Sydney Catholic Schools, Marist North Shore

Engagement with Sydney Metro

**State Environmental Planning Policy (Infrastructure) 2007
State Significant Development Application – SSD-10473
270 Miller Street, North Sydney
Request for additional information**

270 Miller Street, North Sydney (SSD-10473)

Job Name : SCS Marist North Shore
 Sketch Title: Footing Plan
 Date: 03/08/2021
 By: ...

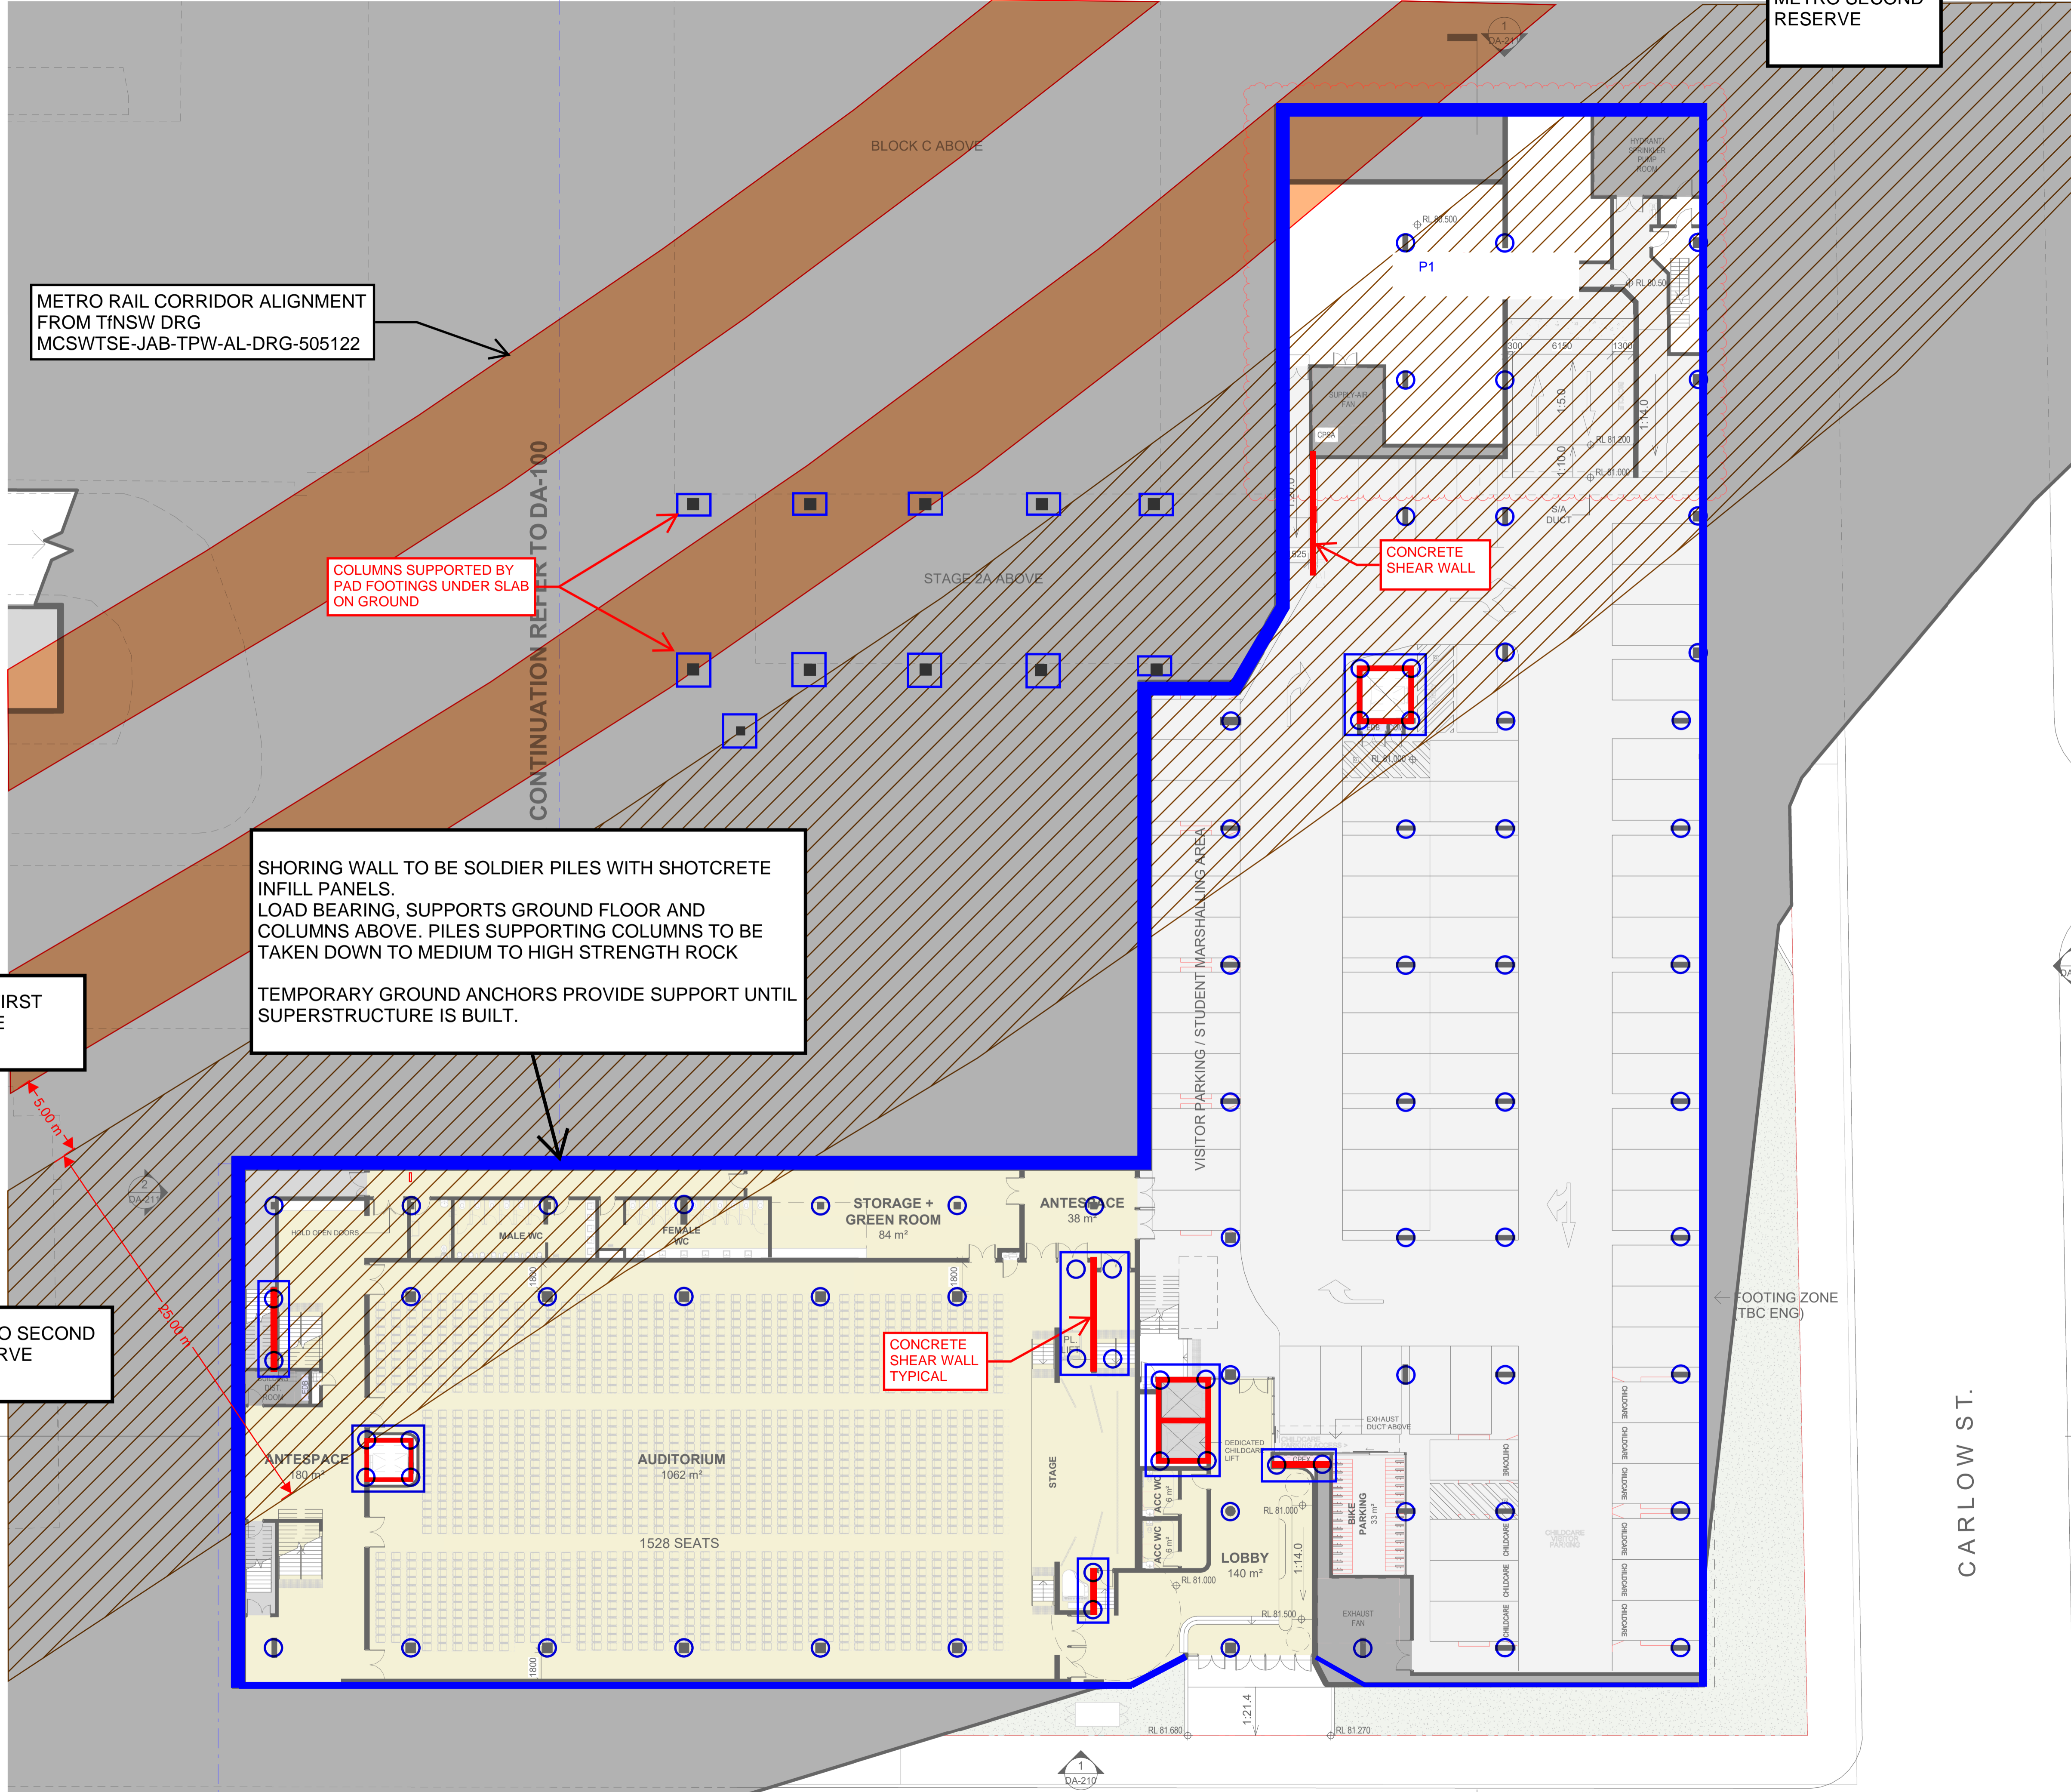
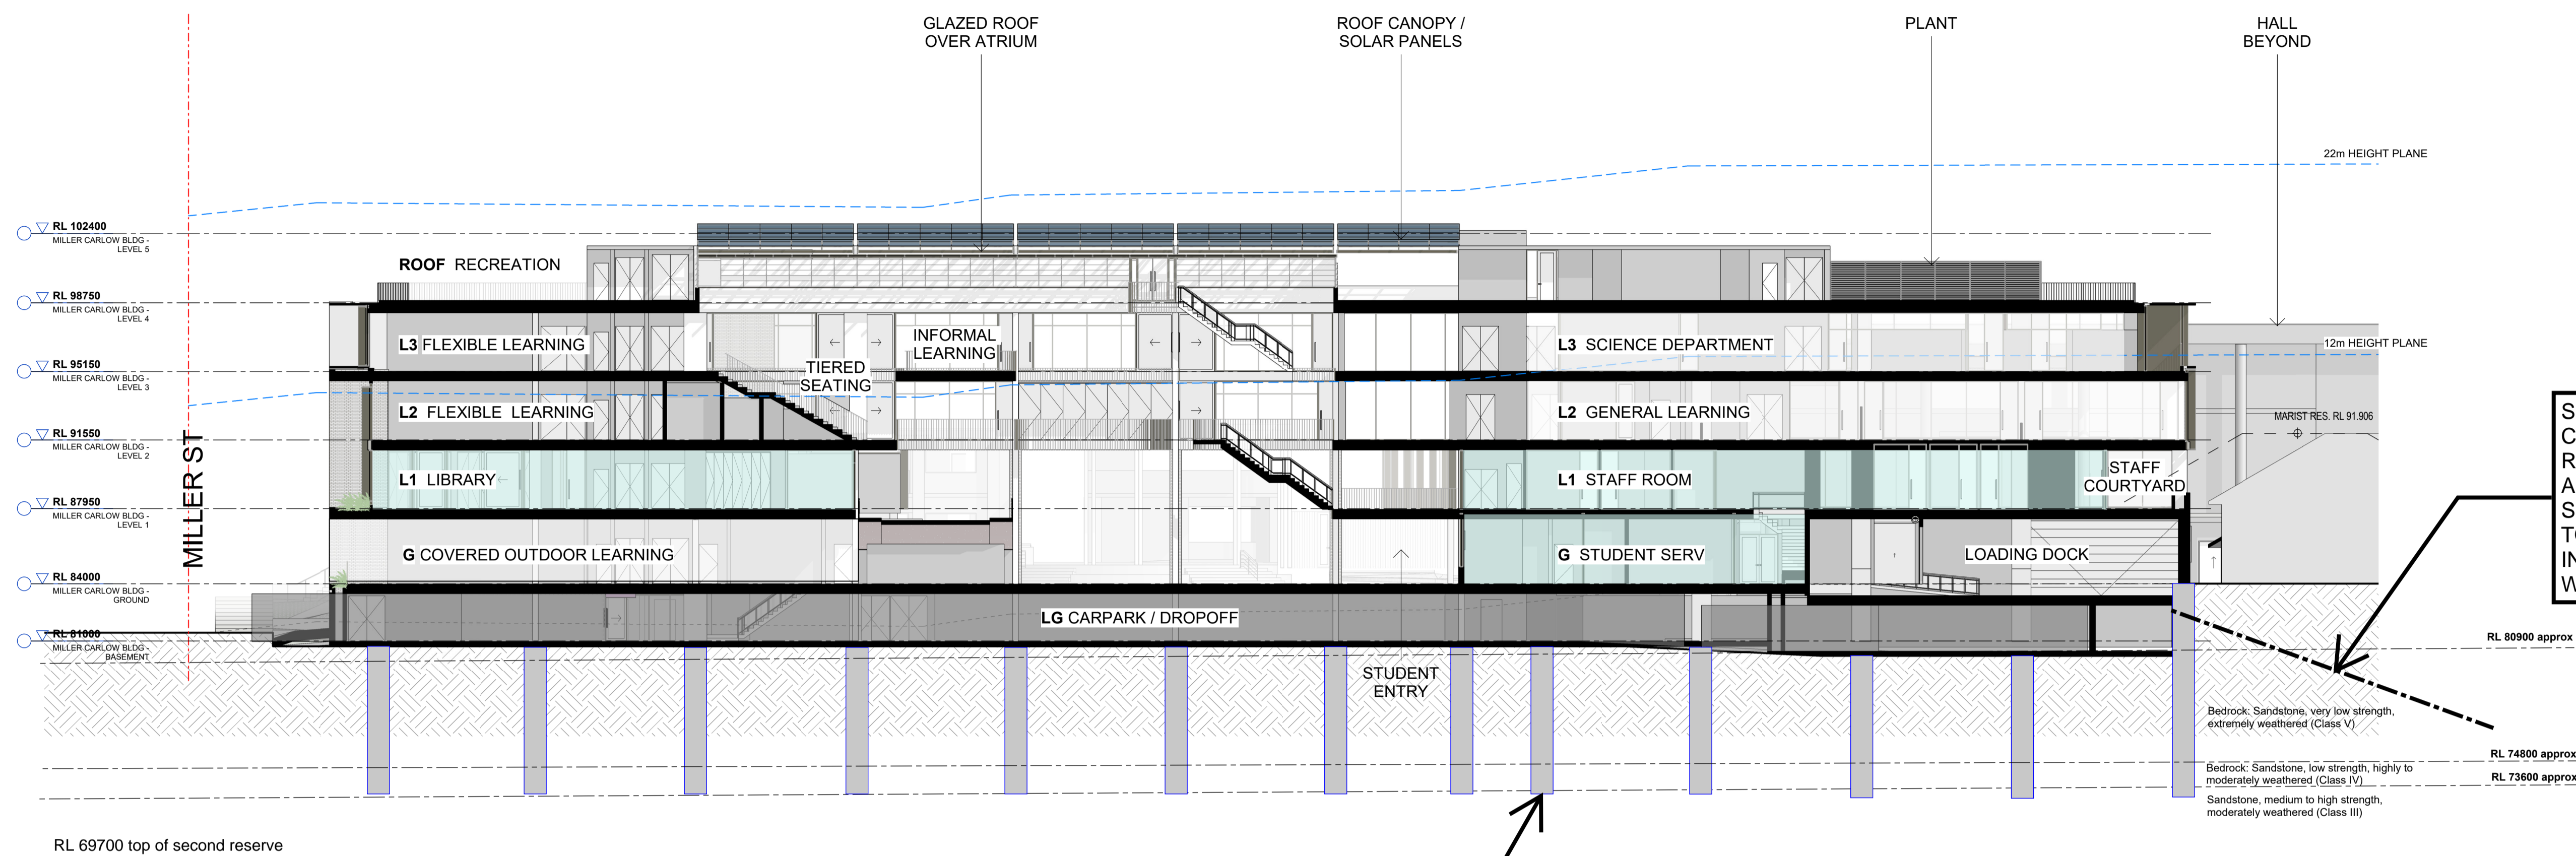
The plan drawing notes temporary anchors to be provided to support retention until superstructure built but the location/extent of these has not been shown. As such, the technical team has requested confirmation that all pile anchors will lie outside the second reserve.

The footing plan (SK210803.MB01) and section (SK210803.MB02) have been updated to include temporary pile anchors which, similar to the pile footing strategy, will lie outside the Metro reserves. I have also attached our SWMS noting the pile anchors as a potential hazard.

- All anchors shall be set out by a Registered Surveyor with sections provided to ensure the anchors do not extend into the Sydney Metro Reserves, prior to commencing works.
